**UNITED STATES
NUCLEAR REGULATORY COMMISSION**
REGION II
245 PEACHTREE CENTER AVENUE NE, SUITE 1200
ATLANTA, GEORGIA 30303-1257

**SUBJECT: NRC SPECIAL INSPECTION REPORT NO. 70-1113/2011-006 AND NOTICE
OF VIOLATION**

Special Inspection Team Charter
Global Nuclear Fuel - Americas
Failure to Maintain Mass Control in HEPA Filter Housing

Global Nuclear Fuel-Americas (GNF-A) NRC Inspection Report No. 70-1113/2011-006

Figure 1: Example of Sinter Test Grinder Filter Housing

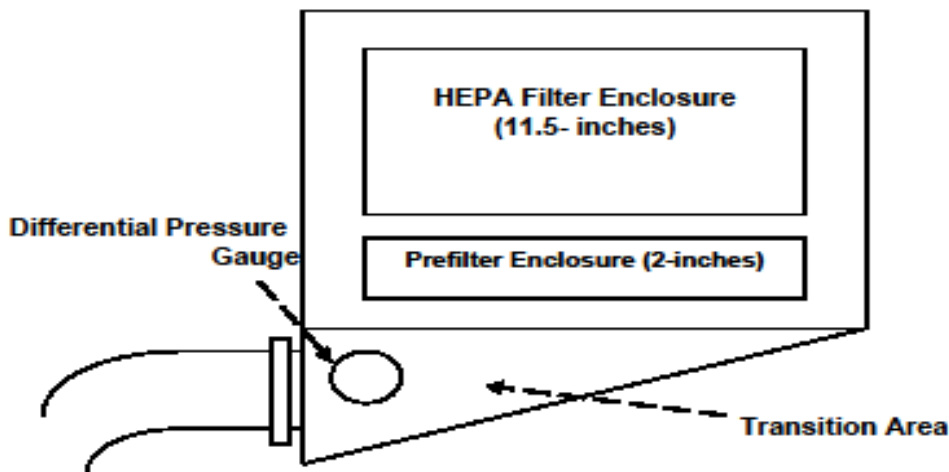
This event description was independently developed and validated by the team using a review of records, logs, and interviews of personnel directly involved with activities prior to and during the failure to maintain mass control within the uranium dioxide (UO_2) sinter test grinding station high efficiency particulate air (HEPA) filter enclosure. Refer to Figure 1 for additional information.

On February 1, 2011, at GNF-A, the licensee identified a high differential pressure (Δp) of approximately 4-inches of H_2O across the ventilation housing of the UO_2 sinter test grinding station. The licensee stated that limiting a Δp of less than 4-inches H_2O would limit mass accumulation to less than or equal to 25 kilograms (kgs) of UO_2 mass. The licensee, using an approved procedure, replaced the prefilter on February 1, which contained approximately 4 kgs of UO_2 powder. The system was returned to service; however, the anticipated reduction in Δp readings was not achieved. The licensee scheduled a HEPA filter replacement for February 5, 2011. The post prefilter replacement Δp reading was 3.2-inches H_2O .
